**ADDENDUM NO. 2
TO THE BID DOCUMENTS**

Project: Homer Harbormaster's Building / DWD Trail Boardwalk
Addendum Issue Date: June 13, 2014
Bid Date: June 19, 2014 @ 2:00PM (Thursday)
Previous Addenda Issued: Addendum #1 issued June 6, 2014
Issued By: Dan Nelsen
Public Works Project Manager
City of Homer
Homer, AK 99603
dnelsen@ci.homer.ak.us

C2 TYP CURVED WINDOW HEAD DETAIL
A6.4 3" = 1'-0" (22x34); 1 1/2" = 1'-0" (11x17)

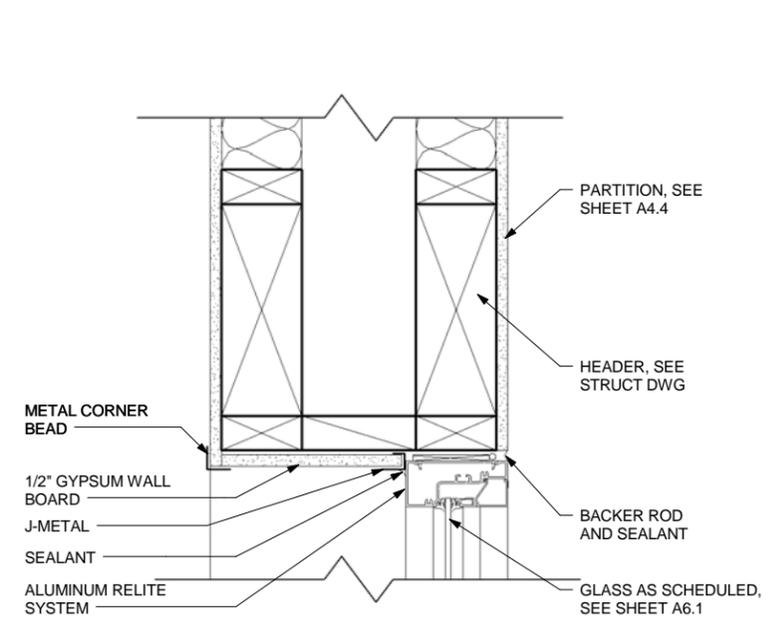
There is no header information for the radius wall headers referenced in C2 A6.4. Please provide header sizes and construction details for incorporating headers into the radius wall, particularly where headers meet 4X2 HSS columns.

Answer: Please see attached revised sheet S2.3 for header callout and add new sheet S5.6 – Revision 1 with header detail included in A/S5.6 Framing Elevation at Radial Wall. Note that wood wall framing is attached to steel tube columns with power fastener.

A ROOF FRAMING PLAN
S2.3 SCALE: 3/16" = 1'-0" (22x34)

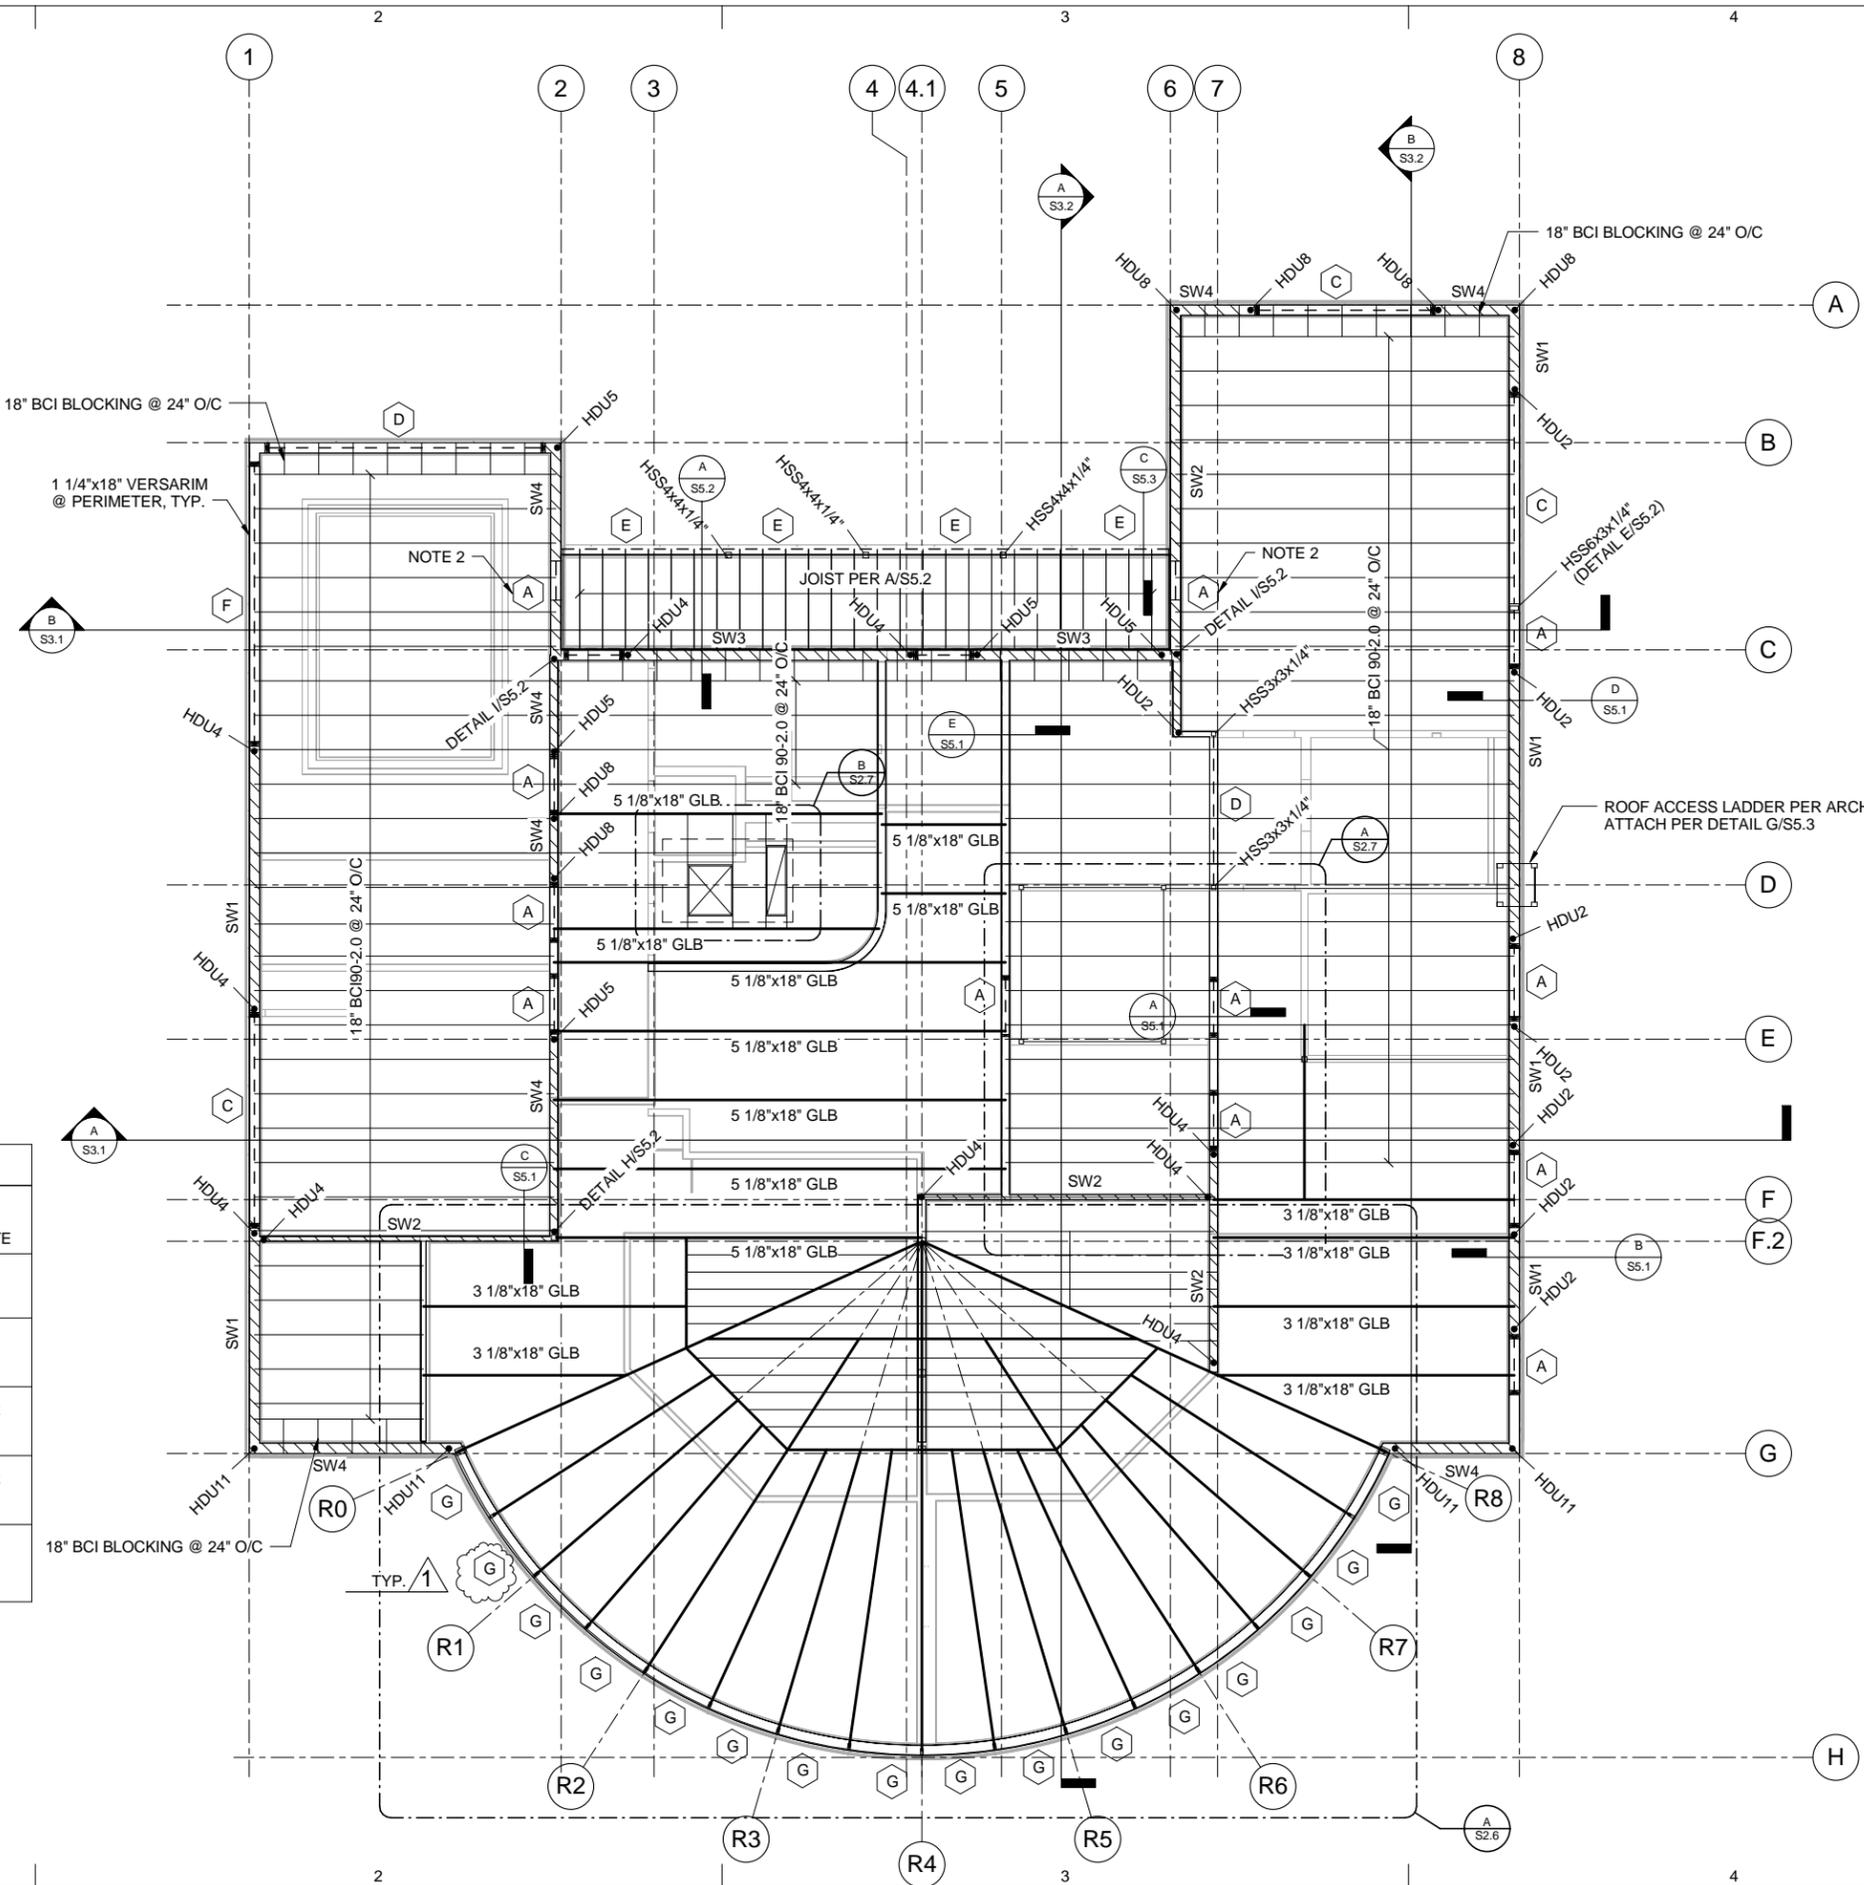
ITEM 6 – Unlabeled Headers

S2.3. There are 2 unlabeled headers in SW3 along GL/ C.

Answer: These two headers are Type A, 4x10.

A
S2.6 ENLARGED ROOF FRAMING @ OVERSLOPE
 SCALE: 3/8" = 1'-0" (22x34)

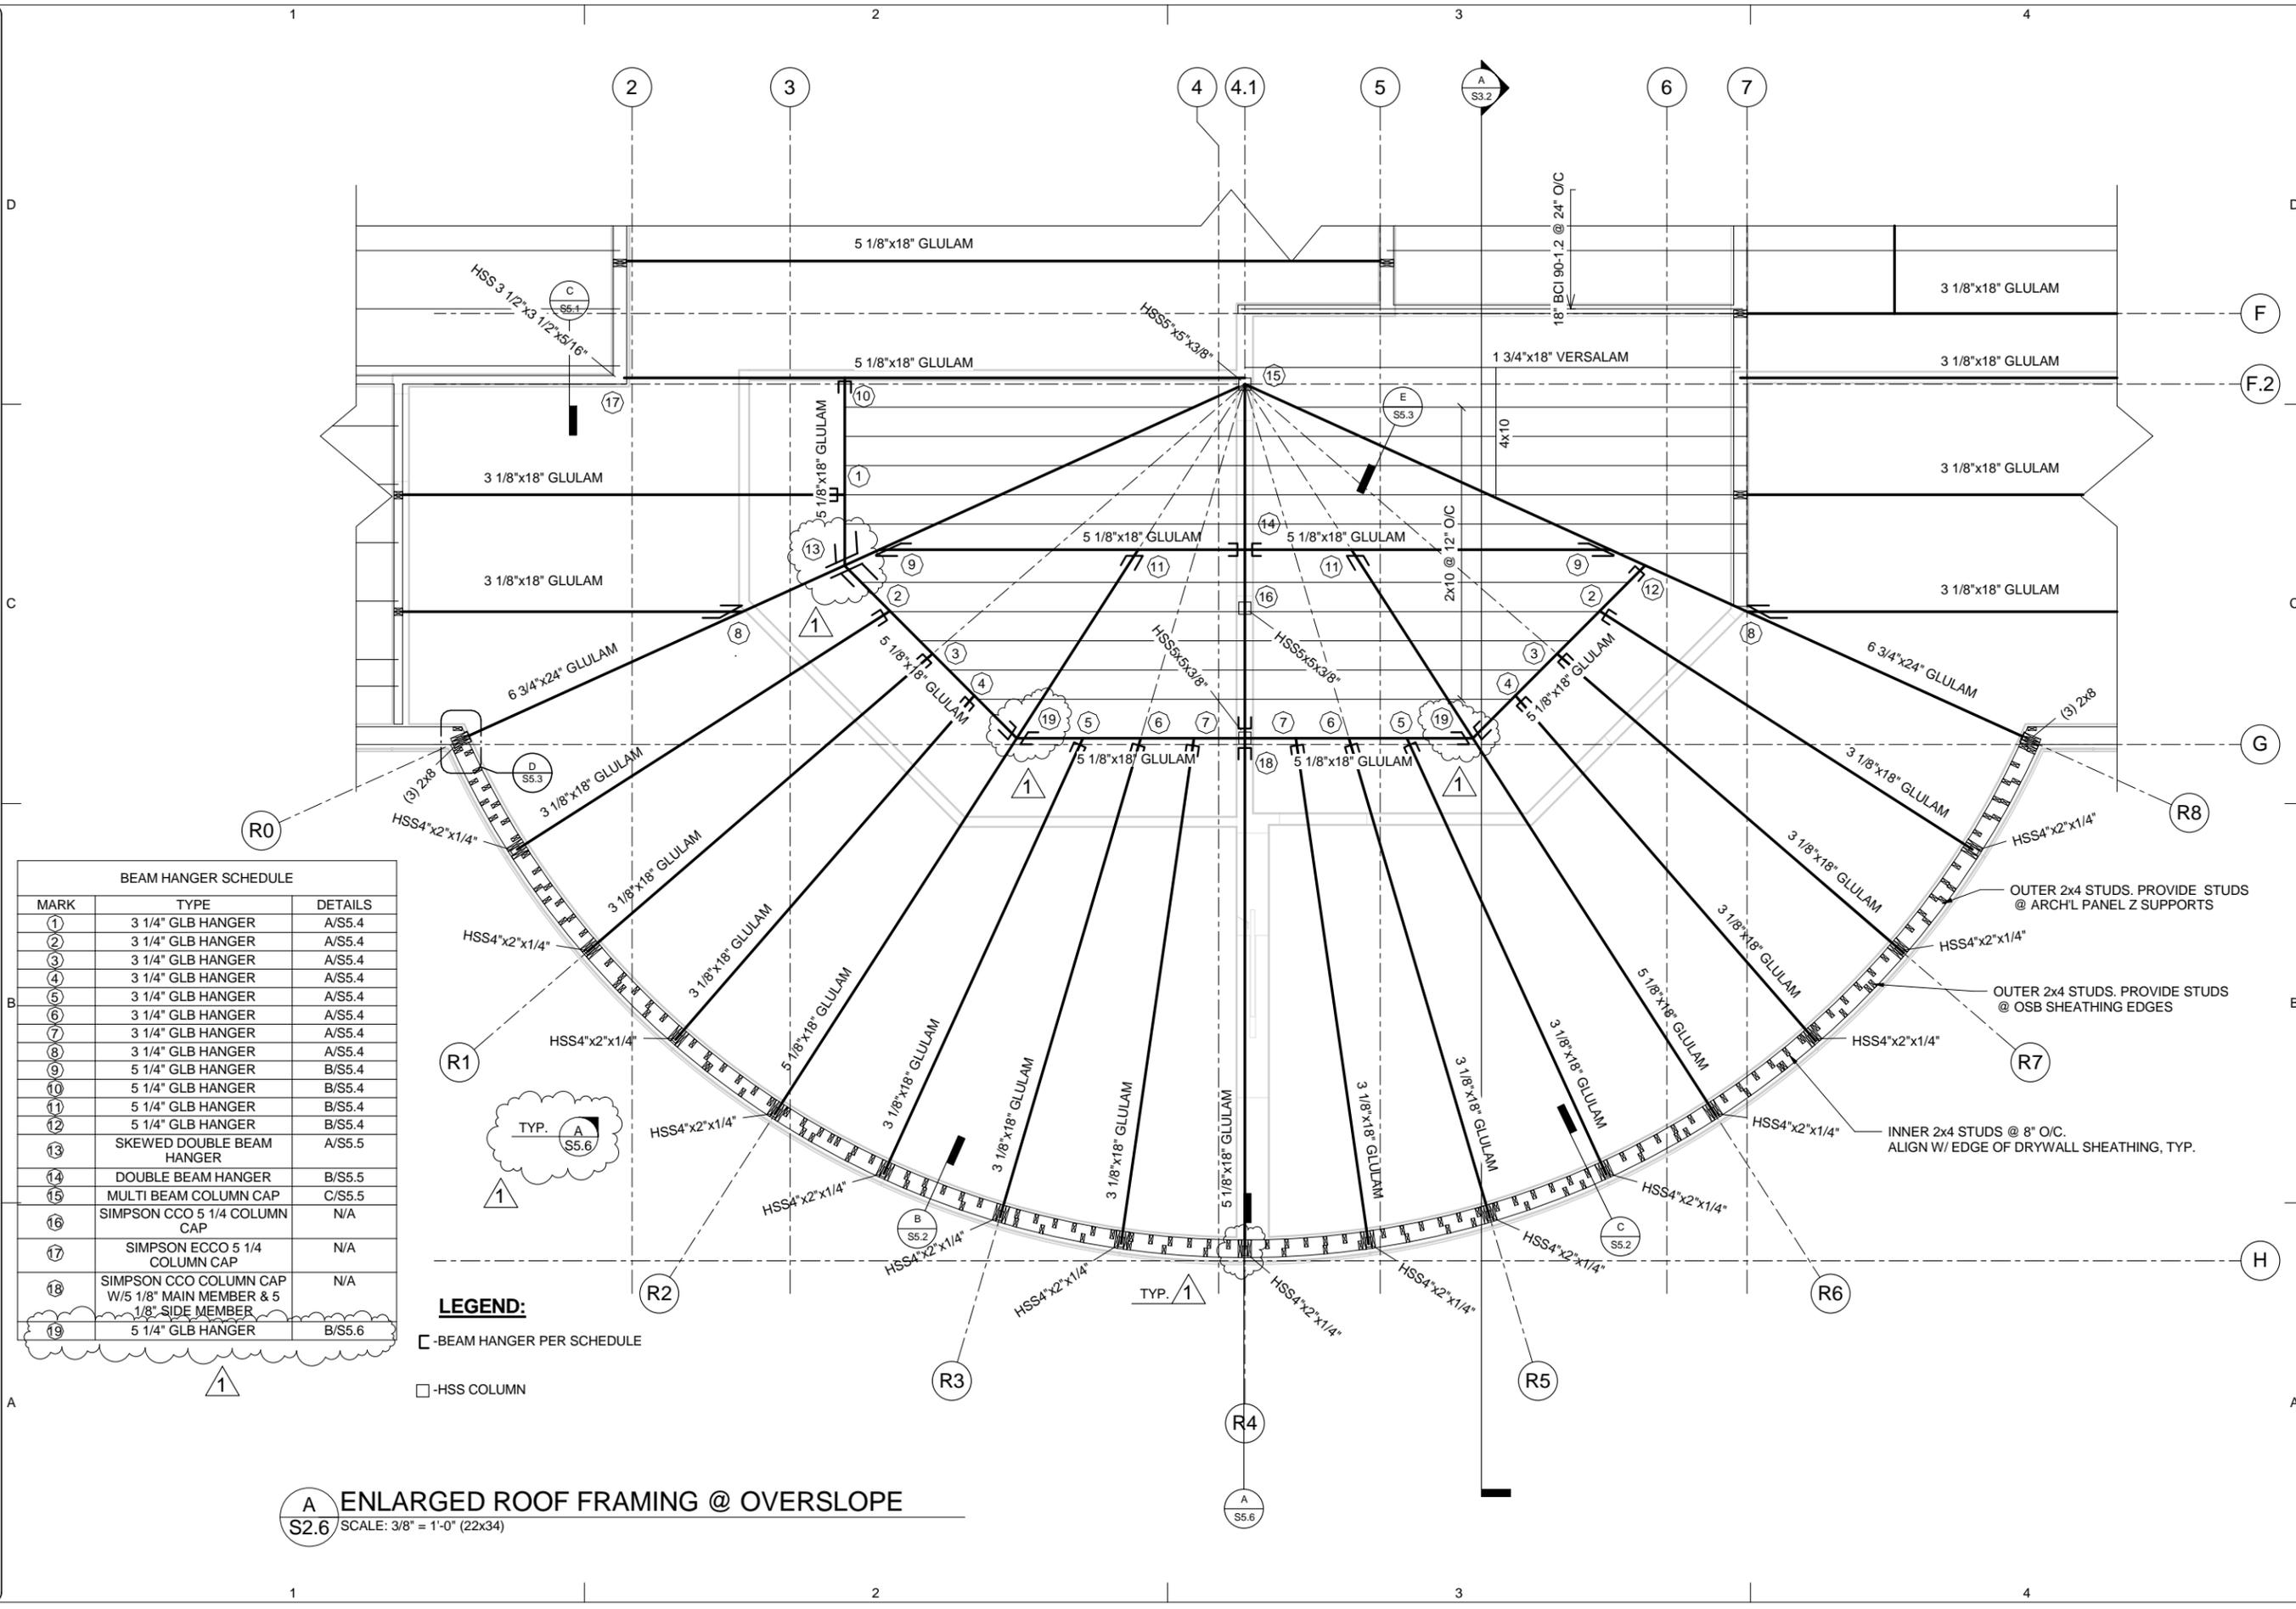
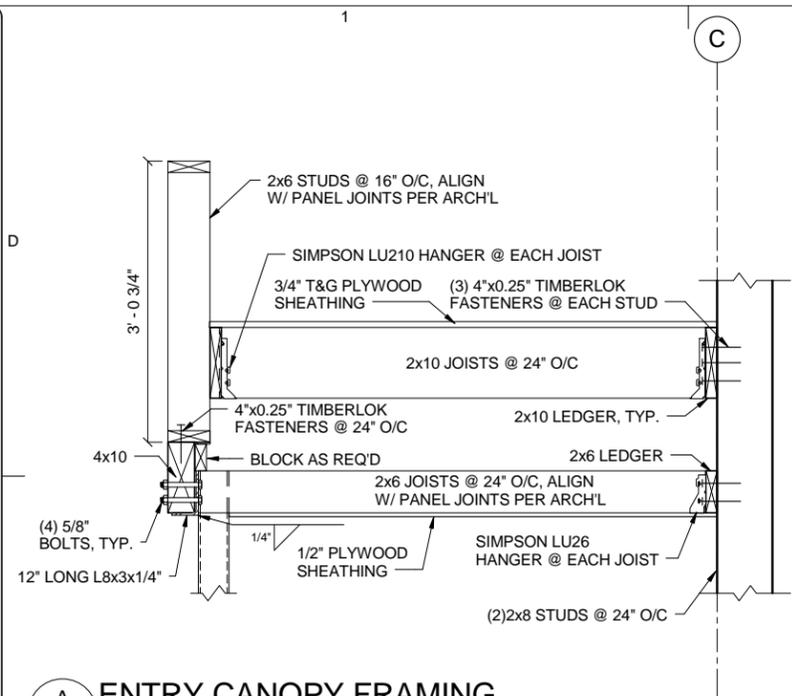
ITEM 7 – Unlabeled Brackets

S2.6. There are 2 unlabeled brackets on the beam along GL R0 near brackets 2 and 9, and these brackets have no detail drawings. Please provide.

Answer: The two brackets are Type 13.

C **MULTI BEAM COLUMN CAP**
S5.5 SCALE: 3" = 1'-0" (22x34)

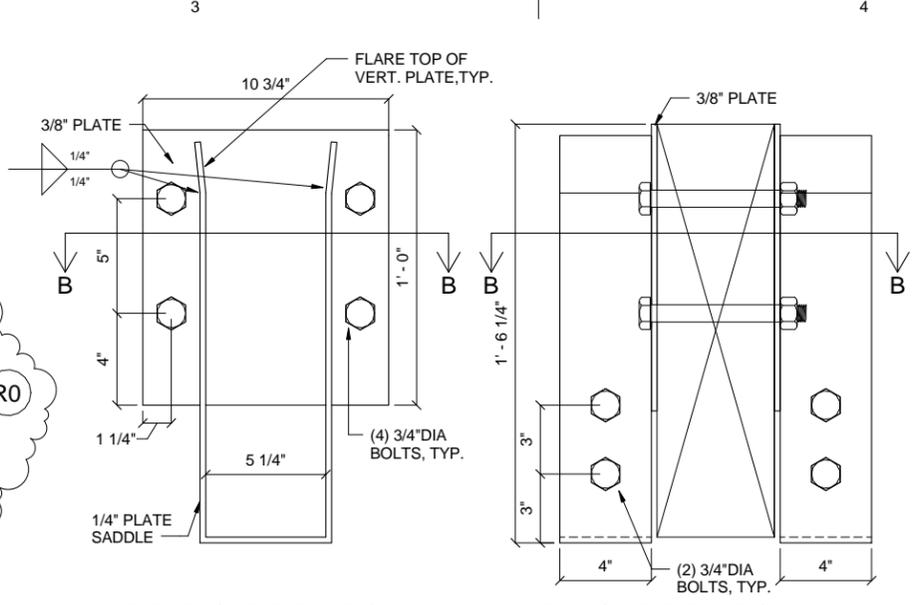
ITEM 8 – Detail “C” on S5.5

S5.5 detail C Bracket number 15 is an intersection of 18" and 24" beams, however, front and side views indicate pockets that will only accept 18" beams. Are the 24" beams intended to be in sockets (without bottoms) not pockets or are these details drawn incorrectly?

Answer: The 24" beams are intended to be in pockets that are 24" deep. Please see revised details on C/S5.5 Revision 1 attached.
